Scoping Summary Report

This report has been prepared in support of the
Southwest Corridor Light Rail project Draft
Environmental Impact Statement

November 2016

Prepared by: Metro

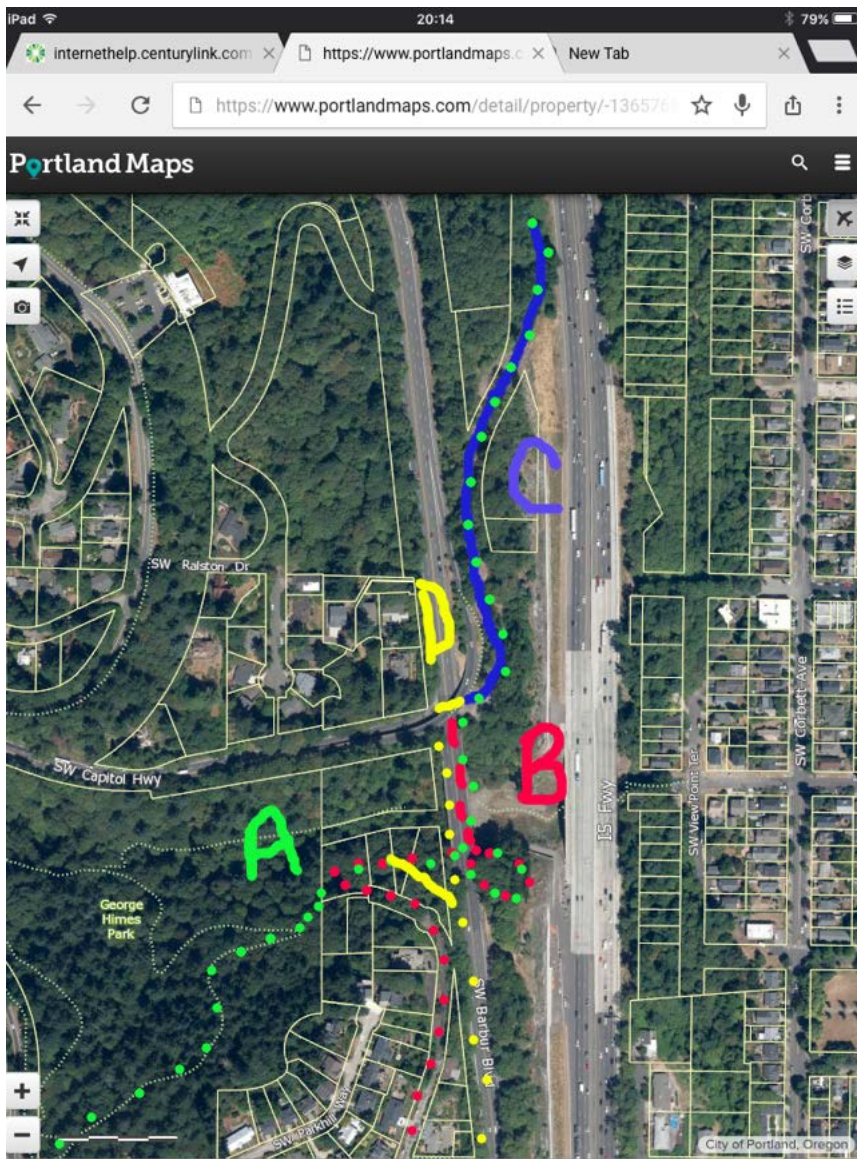
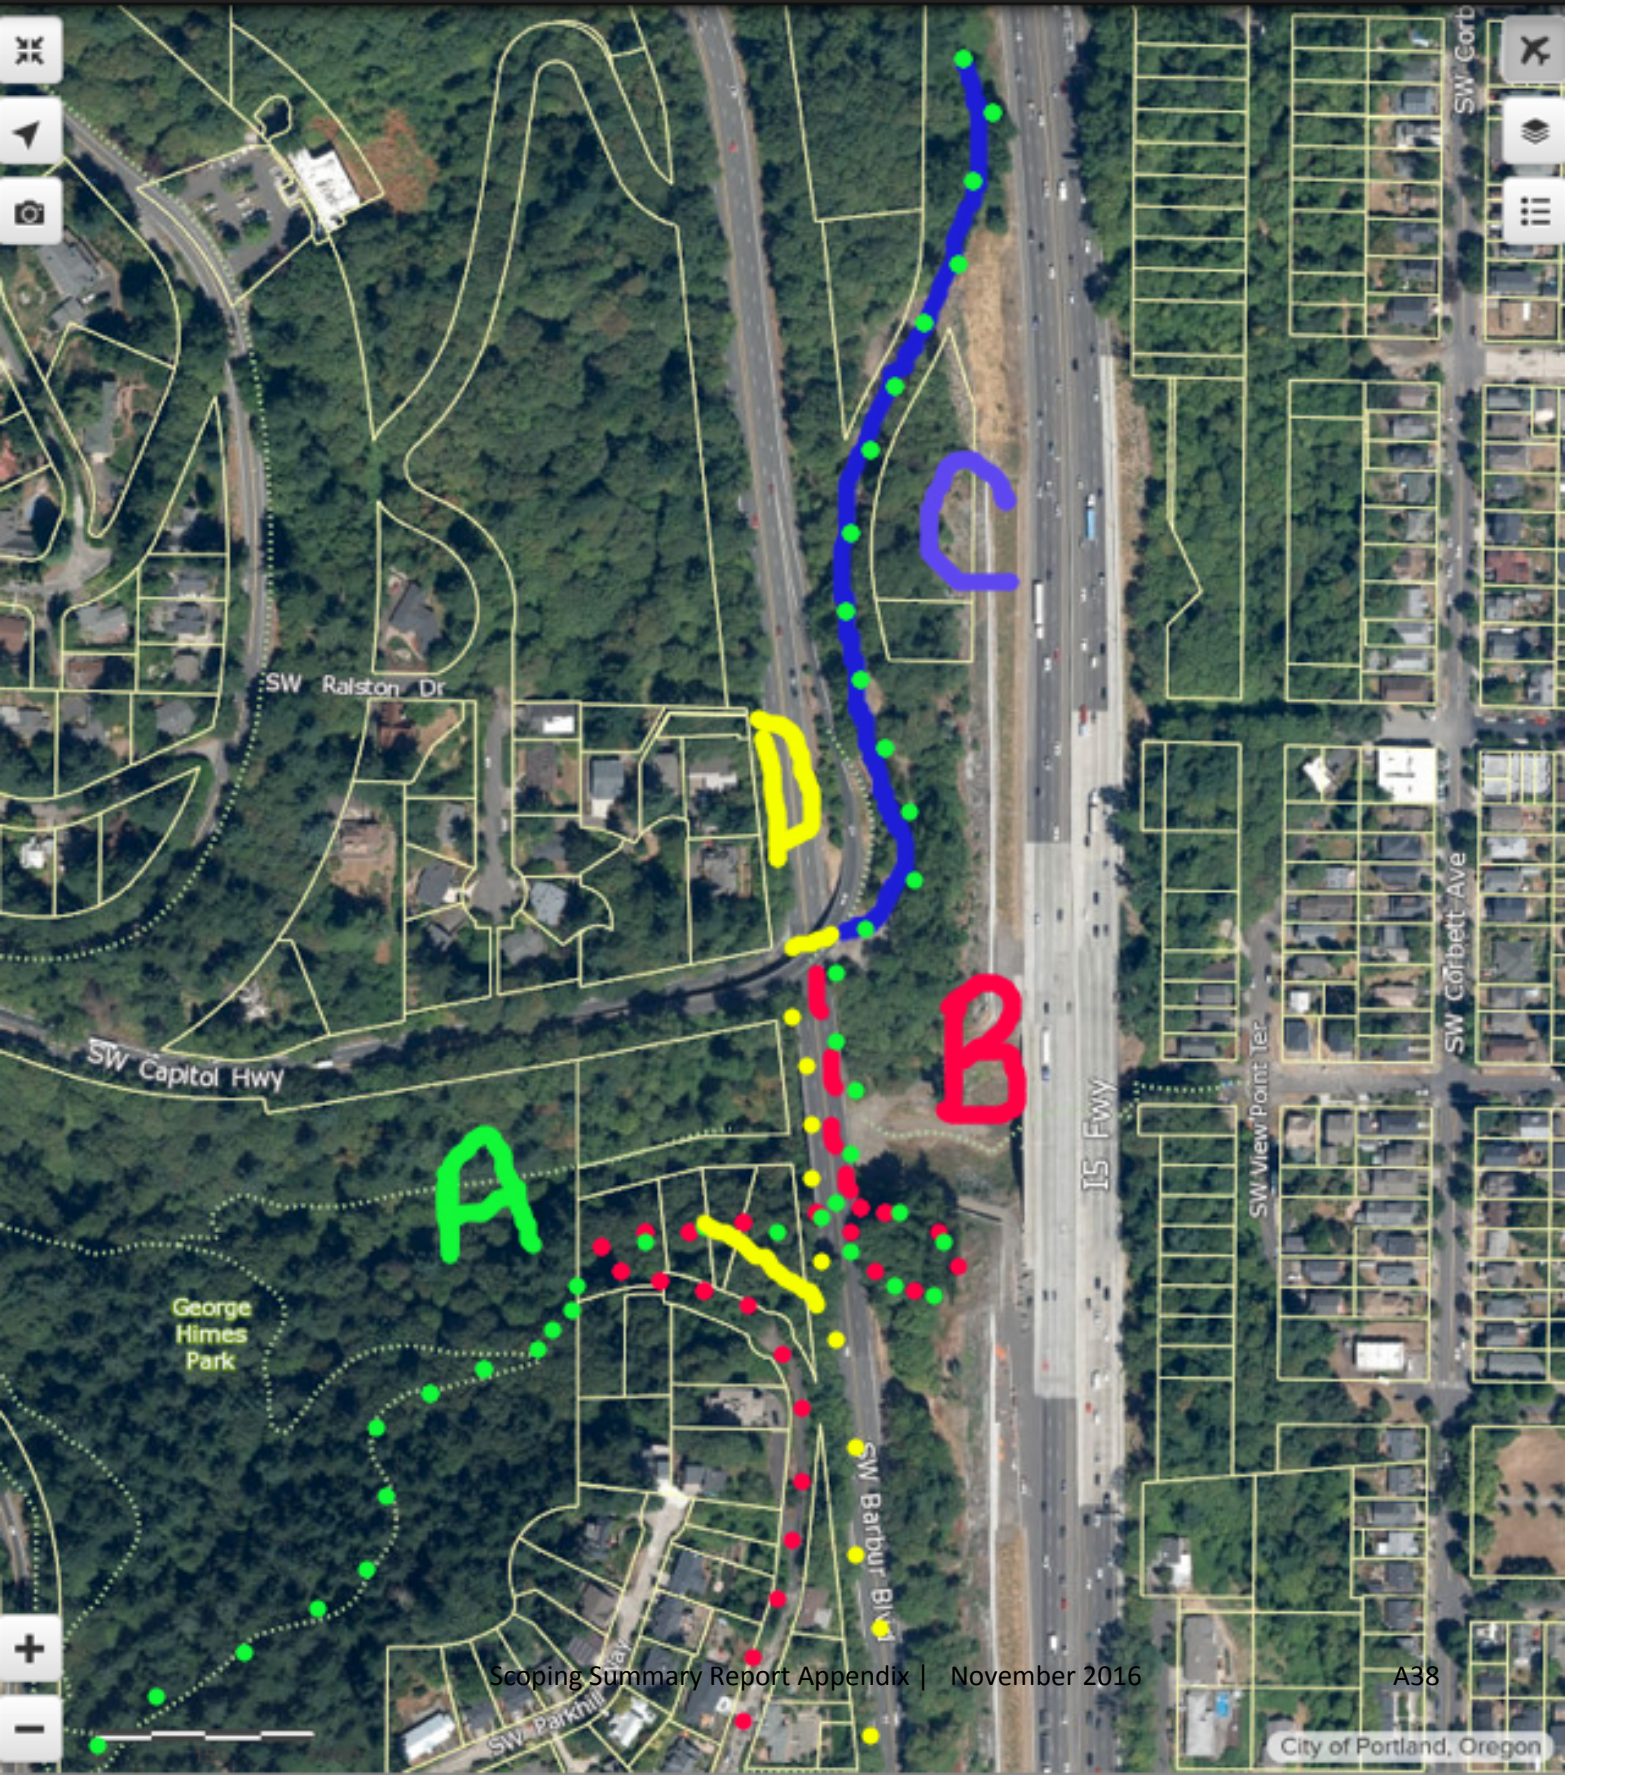
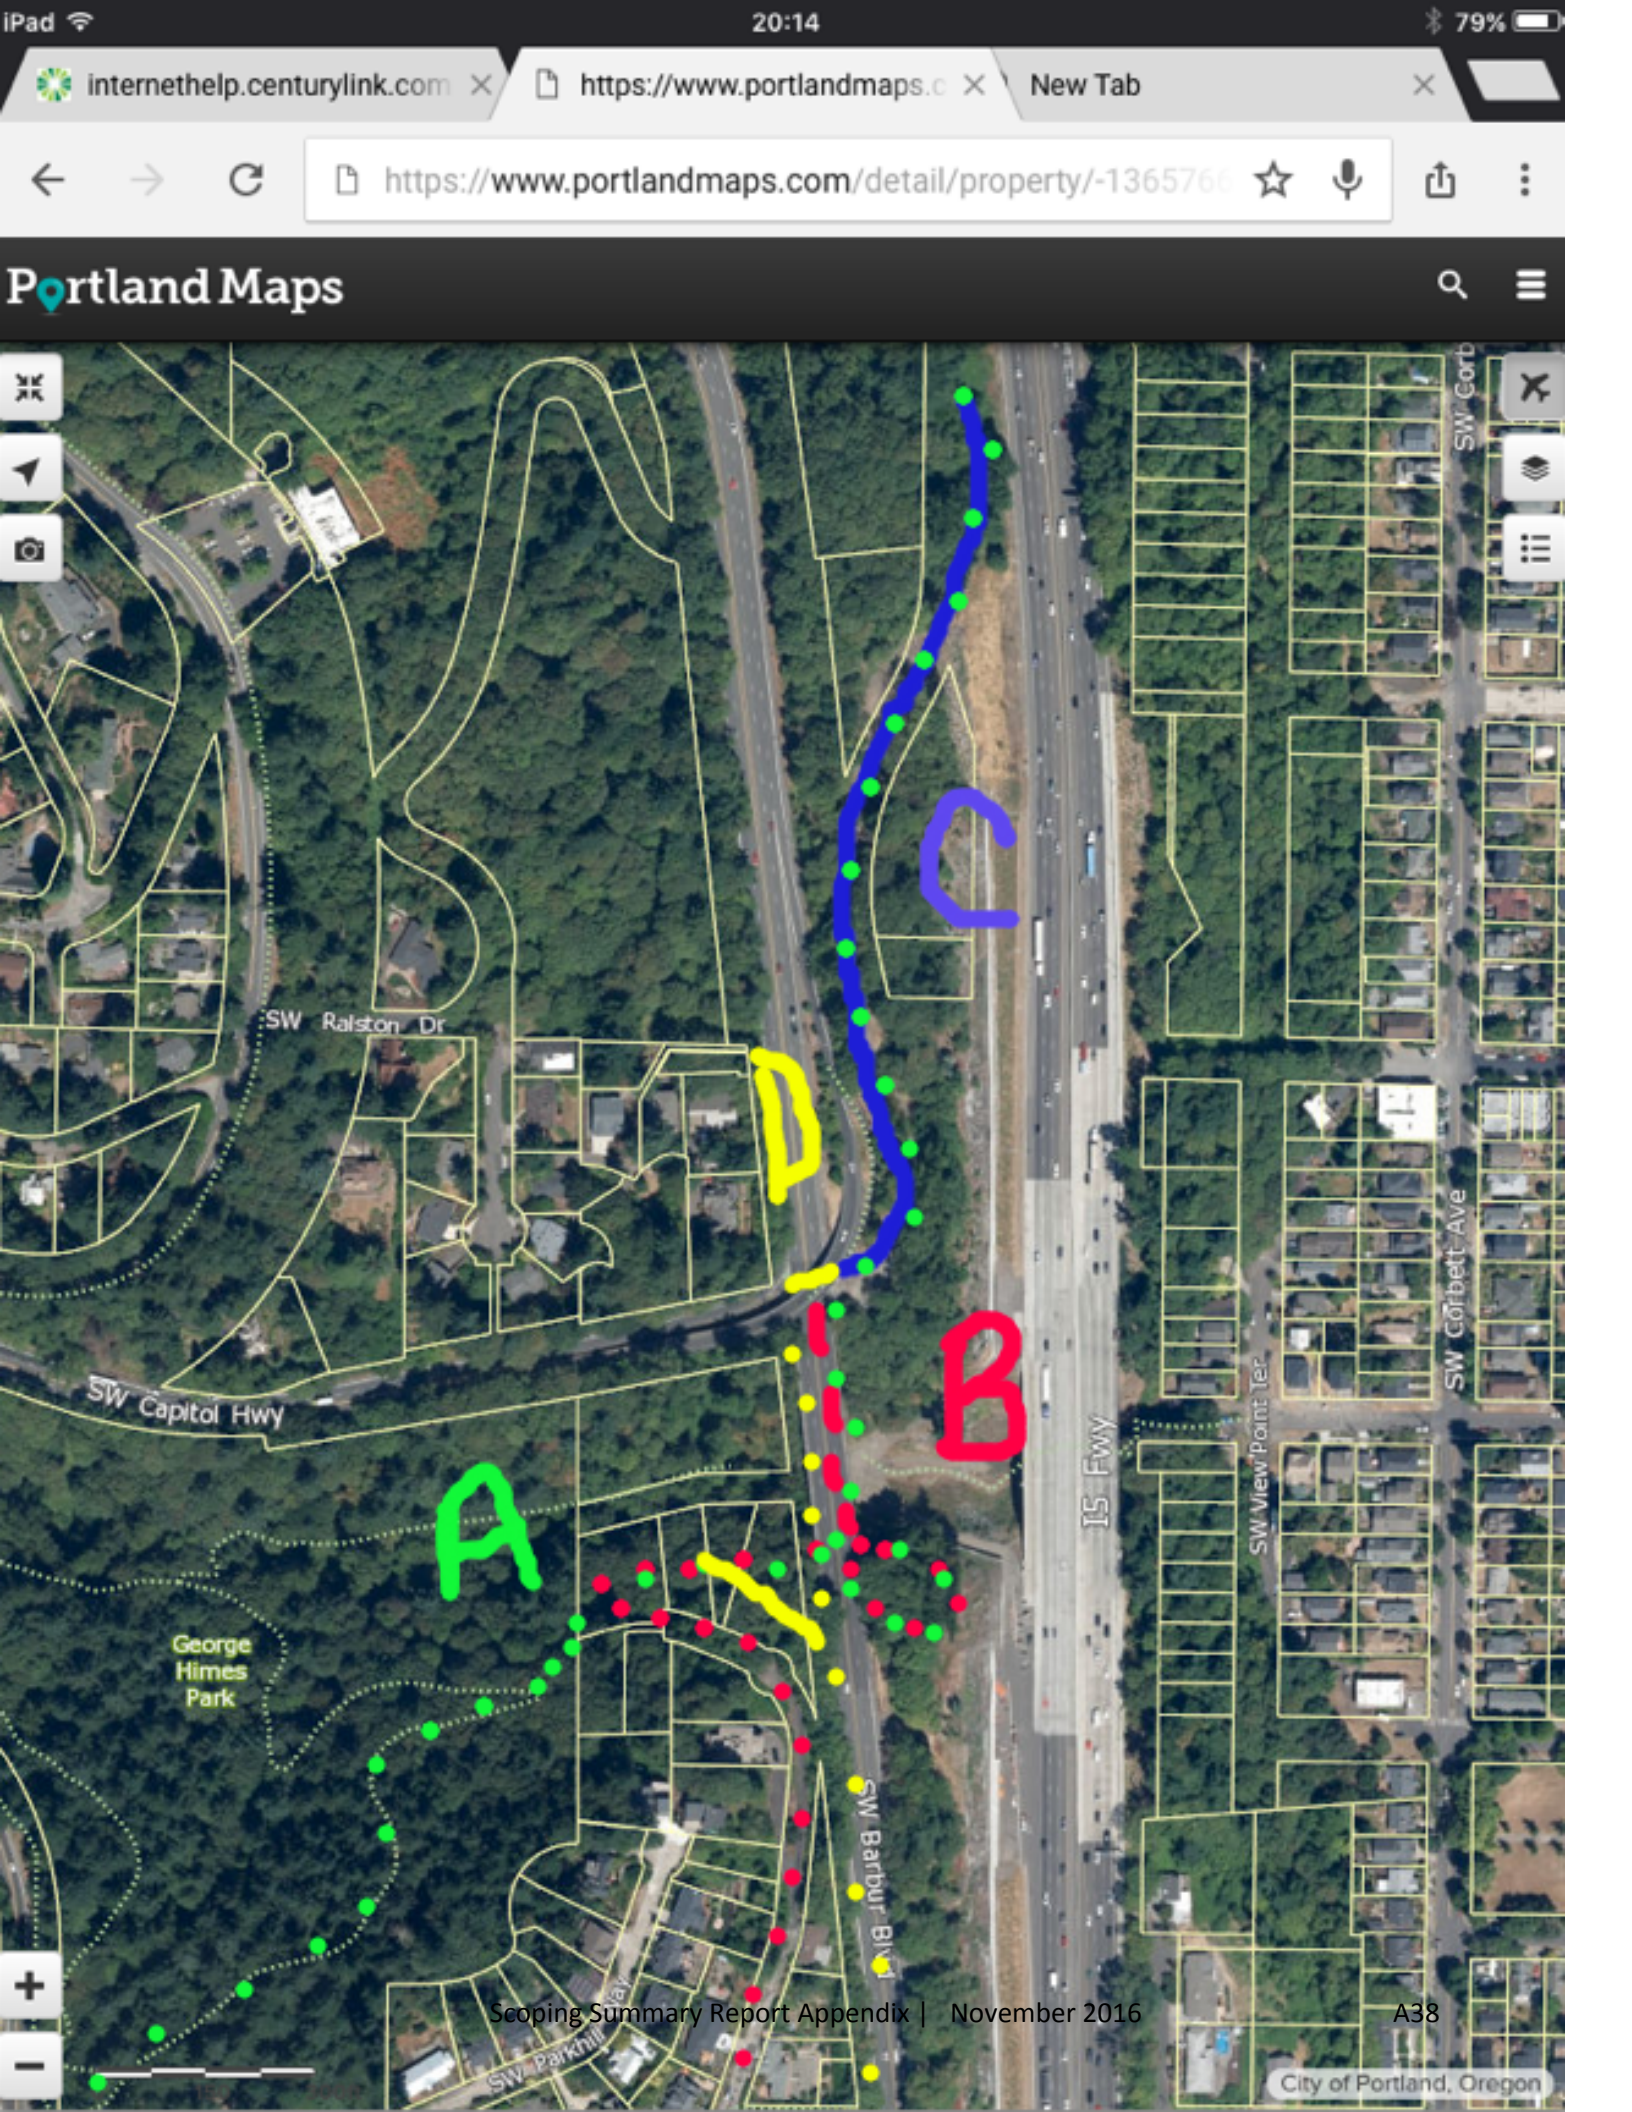
A. The green dots show how the eastbound pedestrians using the trail in Himes Park extended from the switchback (shown in small white dots) to connect with the proposed bicycle linkage described in B below and continue under Barbur at the first bent (cavity) and thence via a loop up onto the Newbury Barbur Bridge (Viaduct) northbound on the east side of the bridge, and thence north along the rebuilt Slavin Road described in C below to connect to Corbett, the Hooley Pedestrian Bridge and get to the Willamette River and the many connections there.

B. The red dots and red dash lines shows the route of the bicycles coming from the west along SW Parkhill Drive to a new trail built to go west a short distance and then switch back and go under the first bent (span or cavity) of the Newbury Barbur Bridge and follow the same route north across the bridge, and then either follow the bicycle lanes on Barbur or follow Slavin Road to connect to Corbett, the Hooley Pedestrian Bridge and get to the Willamette River and the many connections there. The dash lines indicate the new bicycle lane on the Newbury Bridge to accommodate bicycles when the second southbound vehicle lane is removed.

C. The blue line of C indicates the renewal of Slavin Road, utilizing much of the existing street but rebuilding about 700 feet to accommodate bicycles and pedestrians but no vehicles.

D. The yellow dash across Barbur at Capitol Highway indicates a full on demand signalized intersection to allow southbound bicycles and pedestrians from Slavin Road to safely cross from the north end of Newbury Barbur so that they may continue south on the west side of Barbur. The dotted yellow marks indicate the bicycle lane created when the second southbound vehicle lane is removed. The signal would be used by bicycles coming south on Barbur as well as by the bicycles and pedestrians seeking to cross Barbur from Slavin Road. At the south end of the Newbury bridge, the yellow line leading west shows where pedestrians and bicycles would be able to connect to the ped and bike route leading from under the southmost span or cavity of the Newbury Structure and proceed up to Parkhill Drive. See the additional yellow line indicating this connection. (see attached photo with sketch)
